Access Compliance Report

Public Rights-of-Way

(Curb Ramps)

Intersection ID: 50748	Main Street: OPUS_LN	Cross Street: THORN_BLUFF_RD	Location:	N
ADA ID: D4592E59F454	Ramp Type: Perp	Initial Pass/Fail: Fail	Overall Compliance: No	Severity Score: 12.5

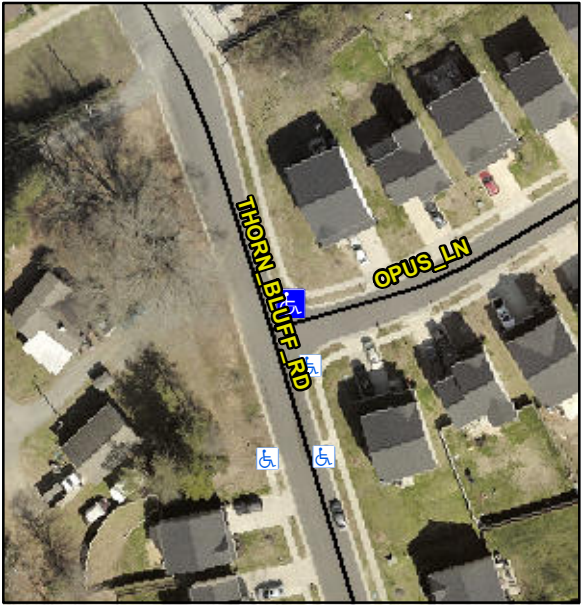
Codes/Mitigation Info/Possible Solution			Field Measurements/Component Compliance		
	Possible Solutions:		Compliance	Description	Data
	Remove & Replace Entire Ramp.		Yes	Ramp Length (in)	47.0
			No	Ramp Width (in)	48.0
			N/A	Flare Type LT	N/A
			N/A	Flare Slope LT (%)	N/A
			N/A	Flare Traversable LT?	N/A
			N/A	Landing Length (in)	N/A
			N/A	Landing Width (in)	N/A
			N/A	Landing Slope (%)	N/A
			N/A	Landing X Slope (%)	N/A
<p>Surveyor Notes:</p> <p>N/A</p> <p>PROW/ADA:</p> <p>Not Found, R304.5.3</p>			N/A	Flare Type RT	N/A
			N/A	Flare Slope RT (%)	N/A
			N/A	Flare Traversable RT?	N/A
			N/A	DWS Provided?	N/A
			N/A	DWS Contrast?	N/A
			N/A	DWS Length (in)	N/A
			N/A	DWS Full Width?	N/A
			N/A	DWS Offset (in)	N/A
			N/A	Shared Landing?	N/A
			N/A	Gutter Ponding?	N/A
<p>Total Cost:</p> <p>\$ 1850.00</p>			N/A	Gutter X Slope (%)	N/A
			No	Painted X Walk1?	N/A
			To S	X Walk 2 Direction	N/A
			N/A	X Walk 2 Width (in)	N/A

2.1	X Walk 2 Slope (%)	N/A
			5.4	X Walk 2 X Slope (%)	N/A
			N/A	Ramp inside XWalk1?	N/A
			N/A	Ramp inside XWalk2?	N/A
			N/A	Road Slope (%)	N/A
			N/A	Road X Slope (%)	N/A
<p>Obstruction Type</p> <p>N/A</p>			N/A	Any Obstructions?	N/A
			N/A	Storm Grate/Utility Hazard?	N/A
			N/A	Storm Grate/Utility Type	N/A
			N/A	Surface Condition? (G/P)	Good
